AGENDA

President and Board of Trustees
Village of Arlington Heights
Board Room
Arlington Heights Village Hall
33 S. Arlington Heights Road
Arlington Heights, IL 60005
January 22, 2019
8:00 PM

Narrative - Changes to Plan

PARKING SPACE TABLE	
TYPE OF SPACE	TOTAL EXISTING
REGULAR	168
HANDICAP	4
TOTAL	172

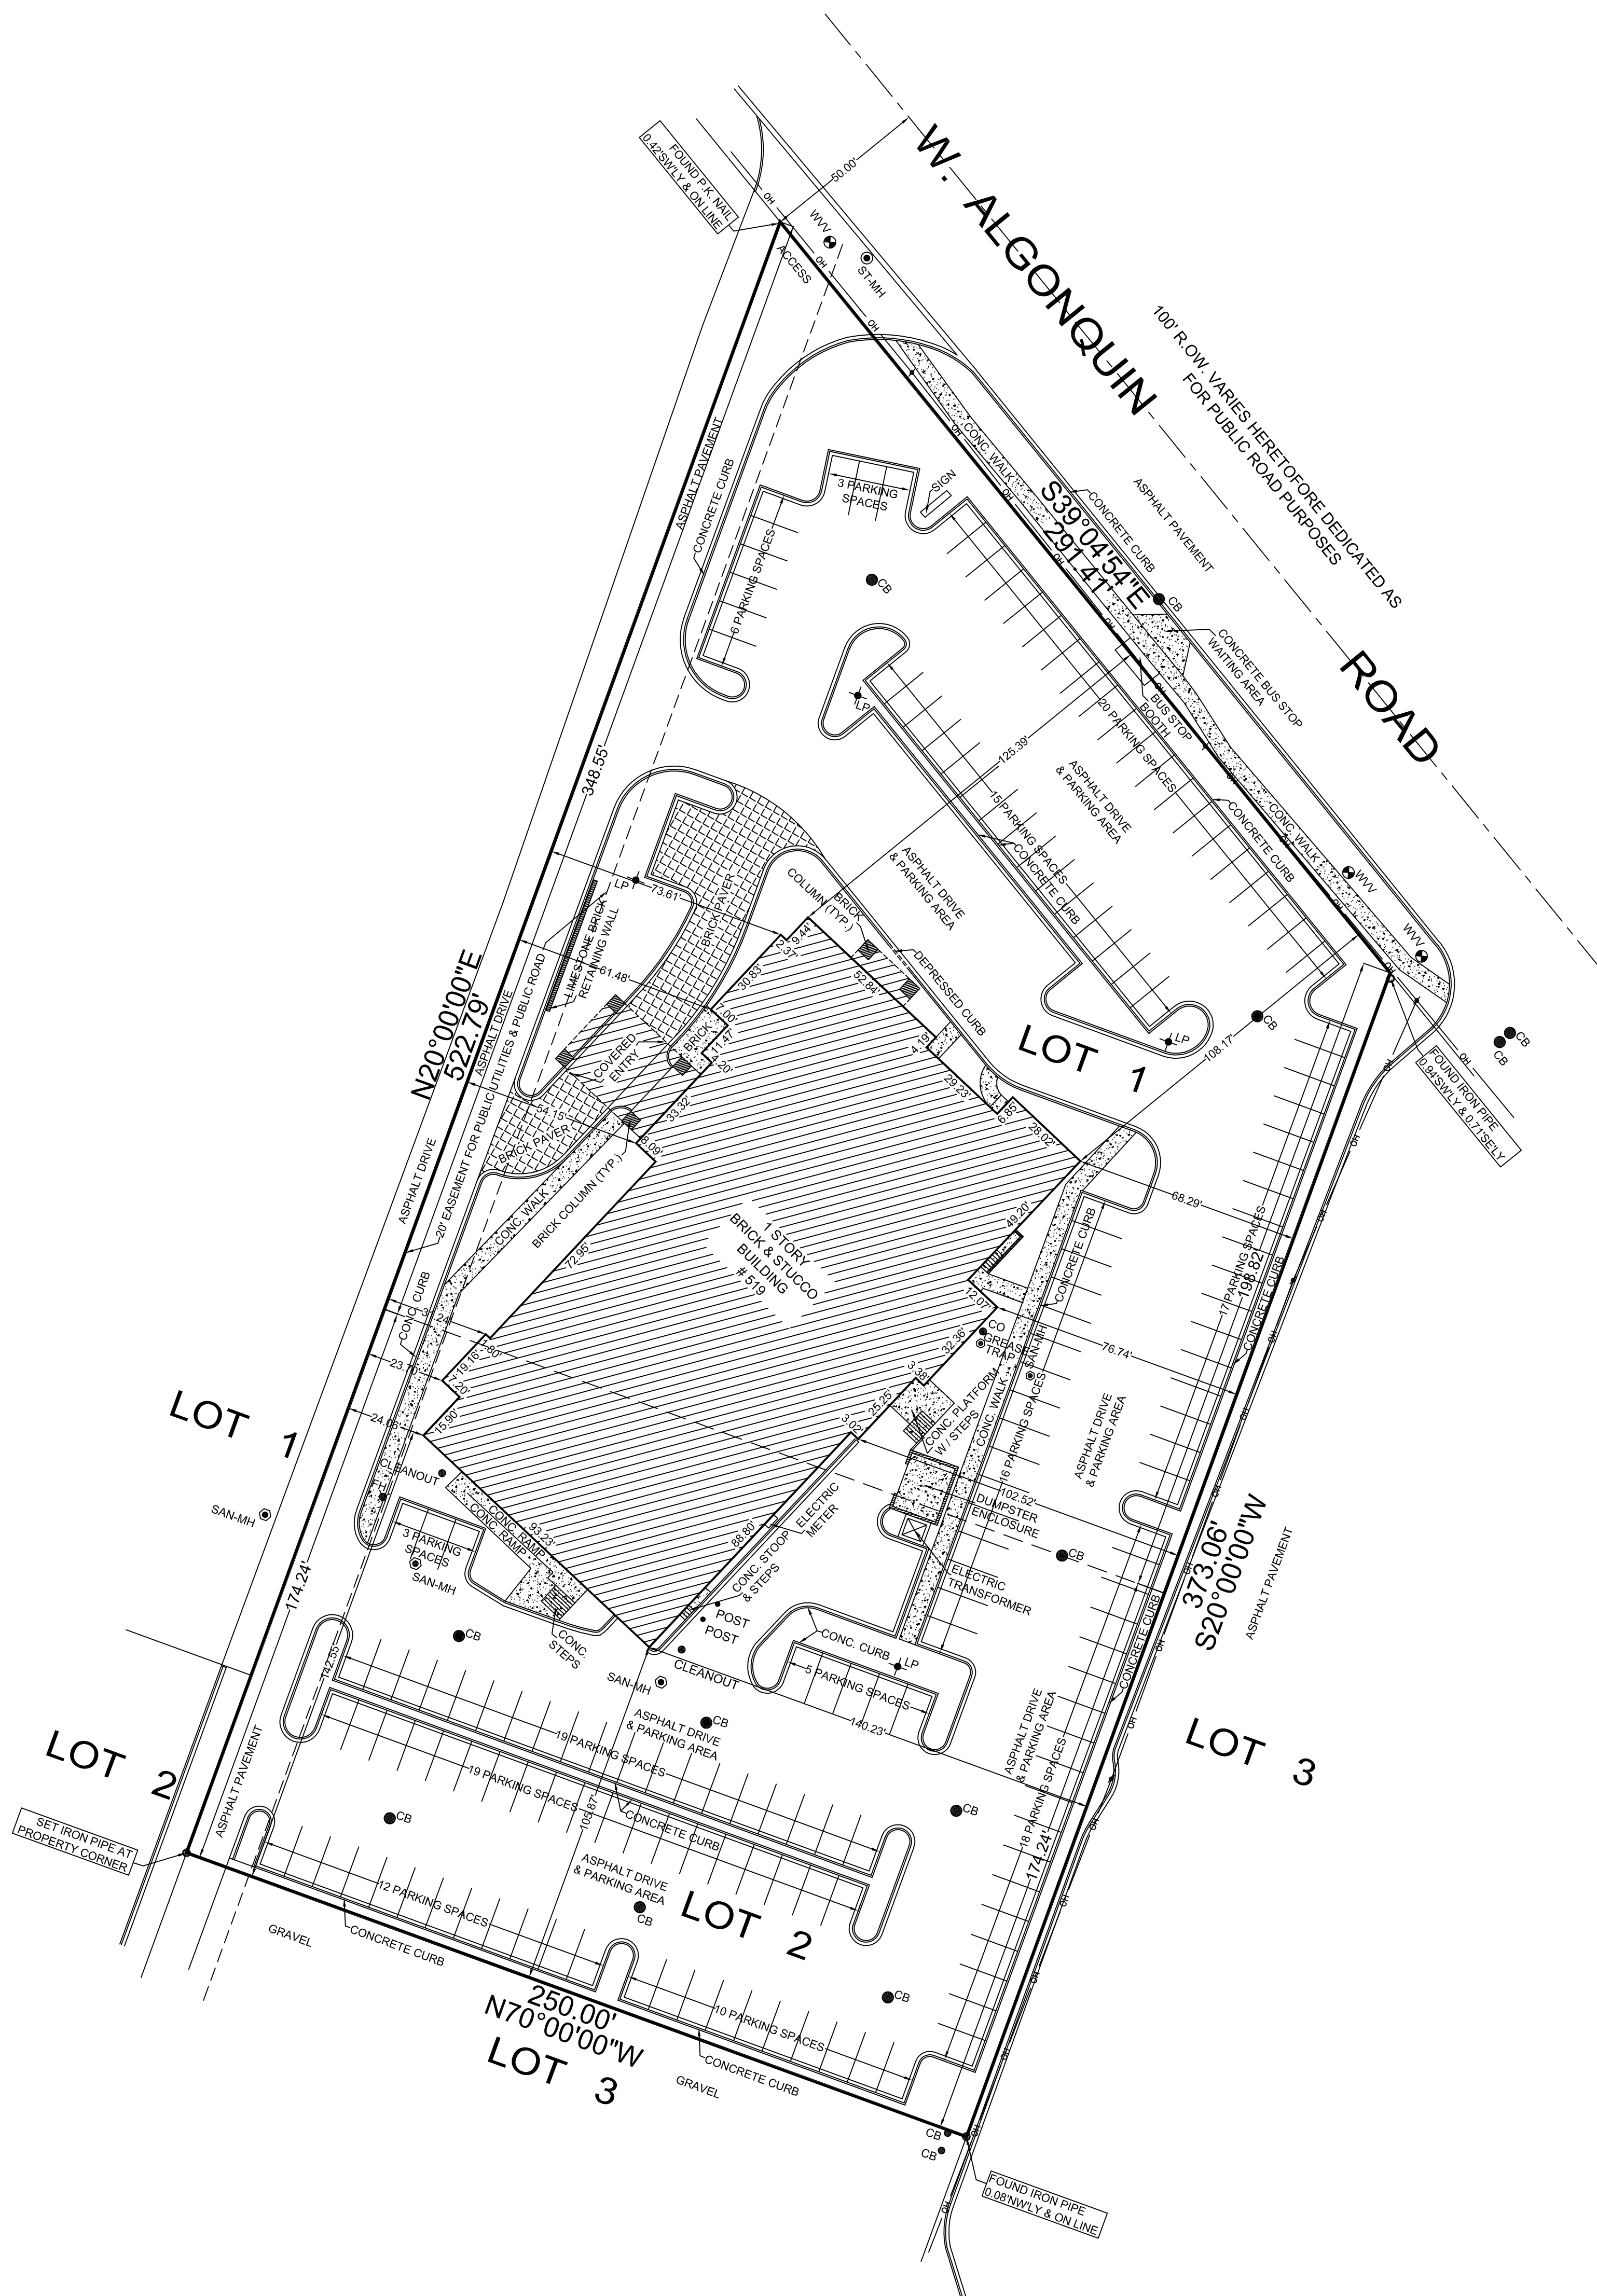
33. The response to comment #16 is noted. Based on a count of the number of parking spaces shown on engineering Sheet 3, 172 parking spaces are proposed. Please note that a parking row of three spaces in the northwest corner of the site has a label indicating that it provides only two parking spaces. Furthermore, sheet 3 has note indicating that the total number of parking spaces provided is 171 spaces. These items must be revised on the permit submittal.

1 SECOND FLOOR PLAN
1/8" = 1'-0"

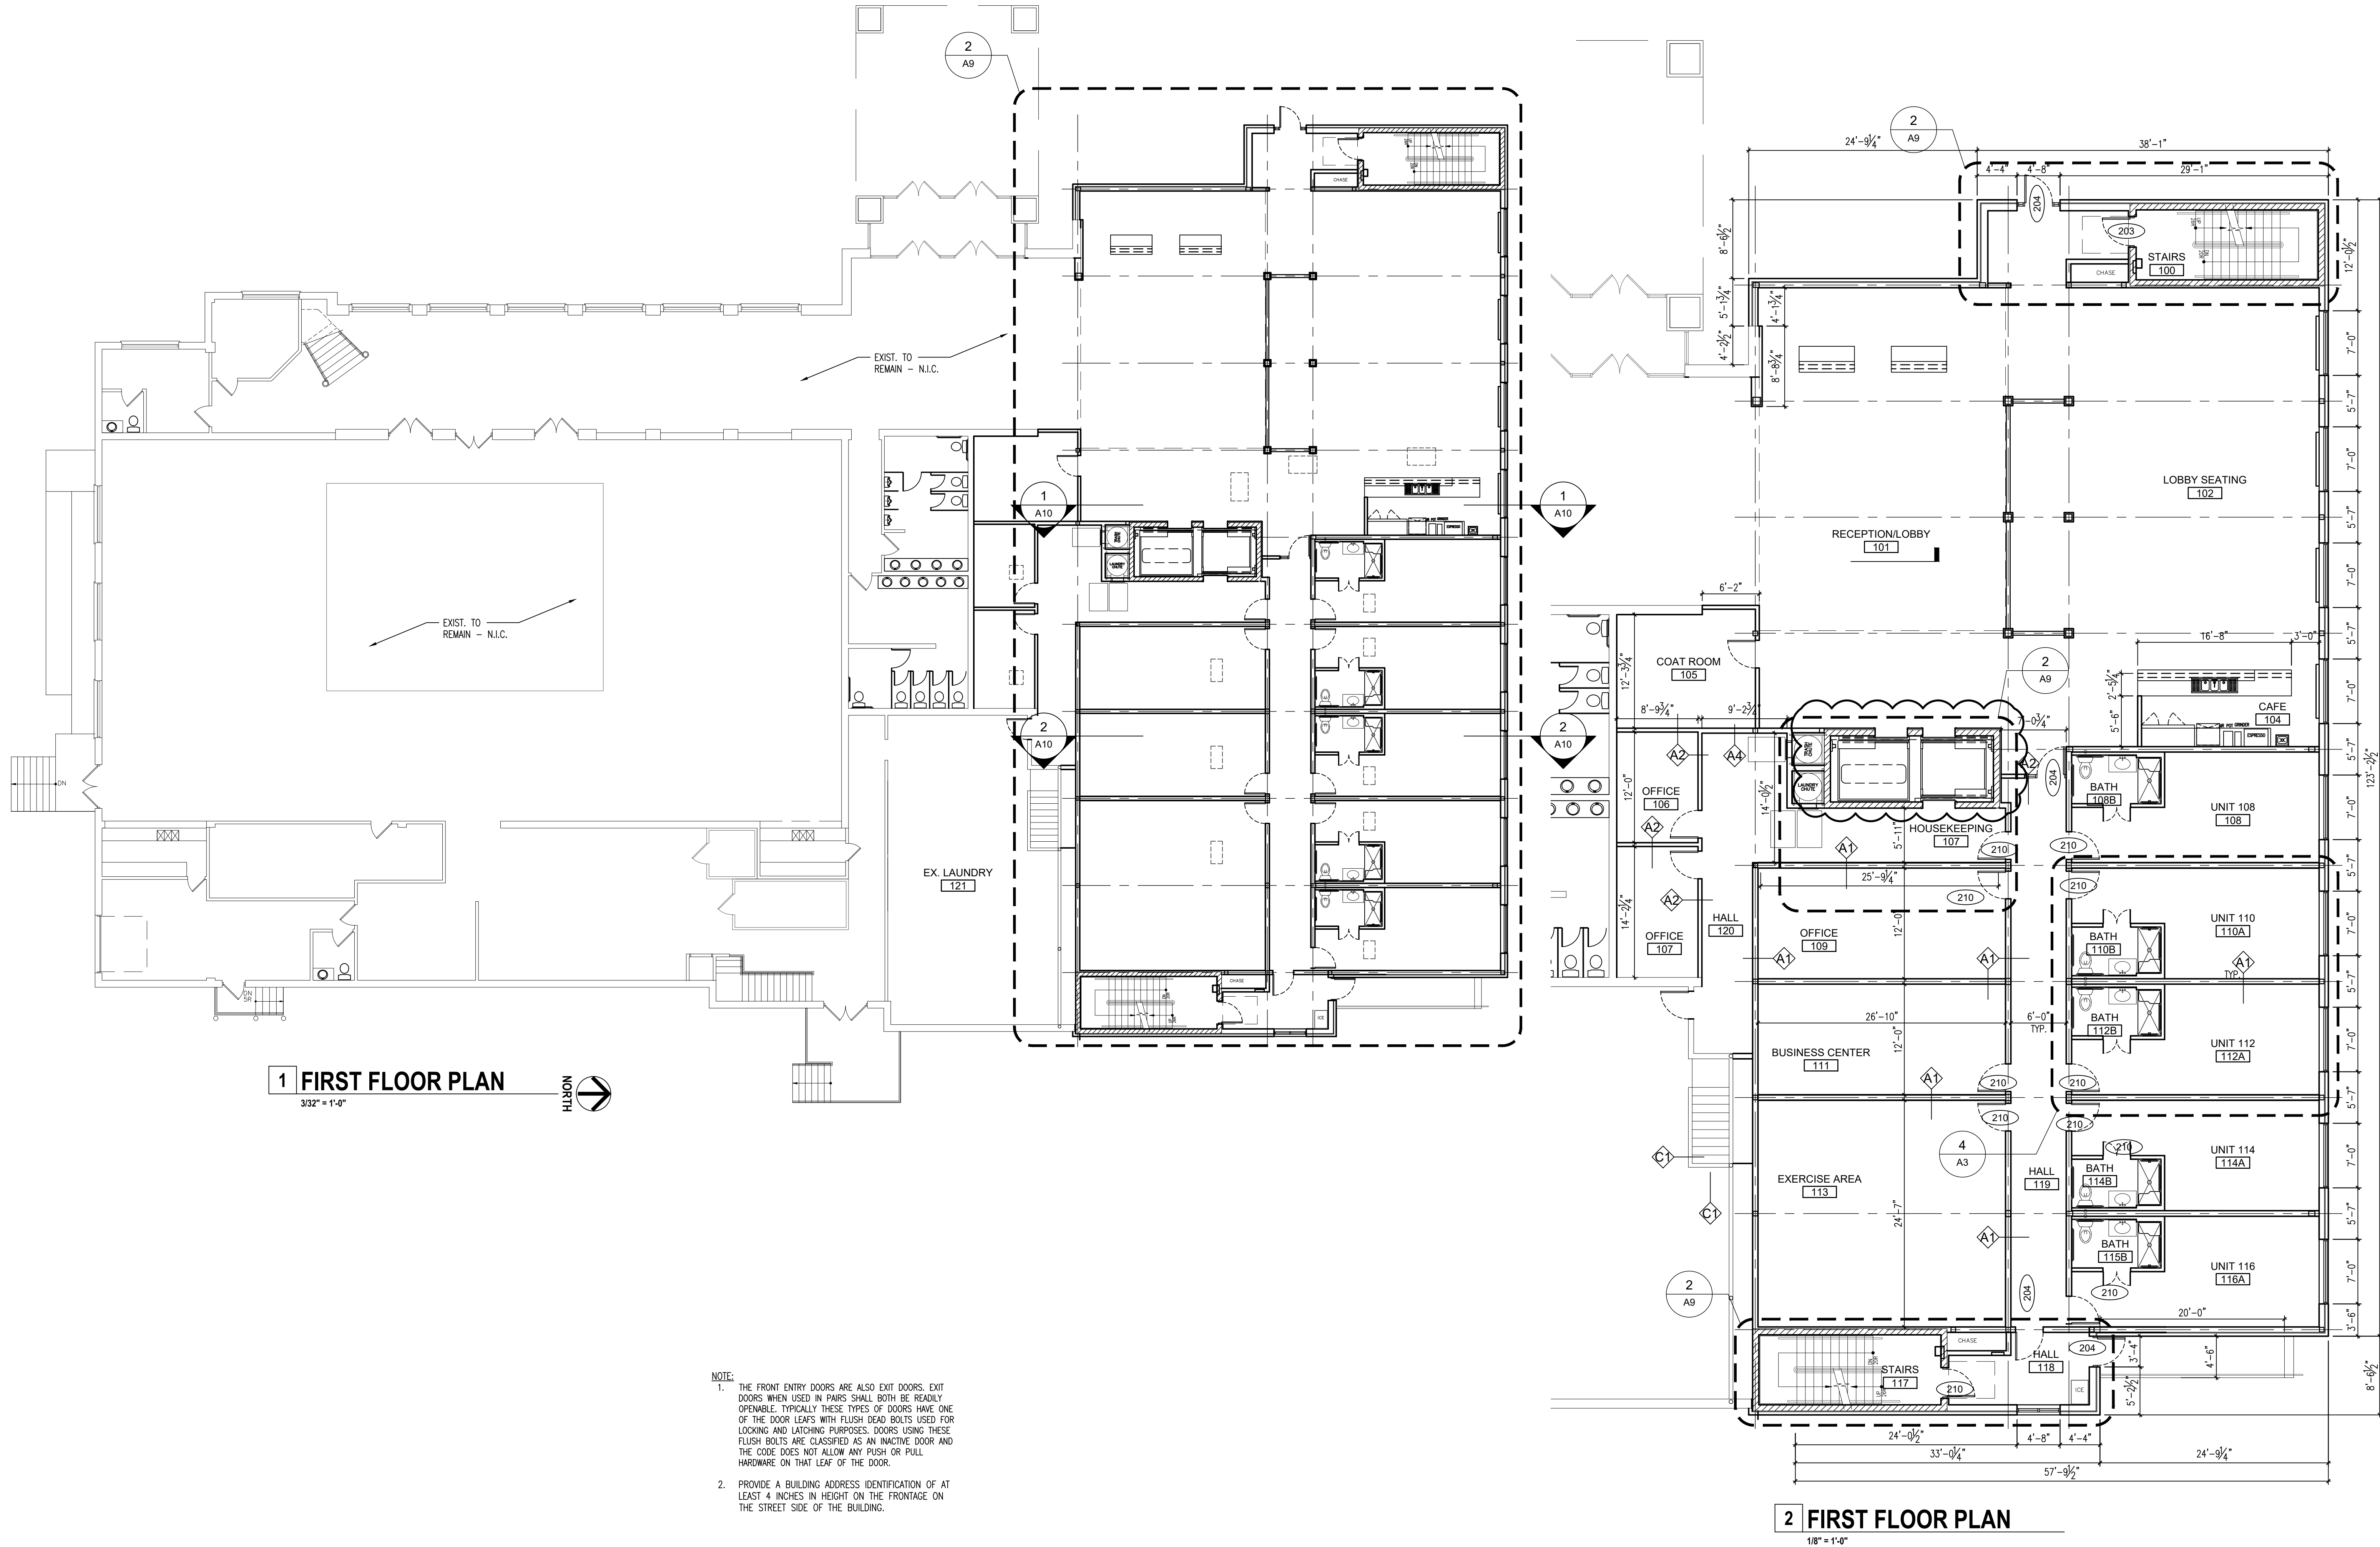
13. Sheet A2 has a label for "Second Floor", which appears to depict the first floor. Please correct.
14. There is an office on the 2nd floor that appears to be a hotel room. Was this office mislabeled, or will this space actually be used as an office?
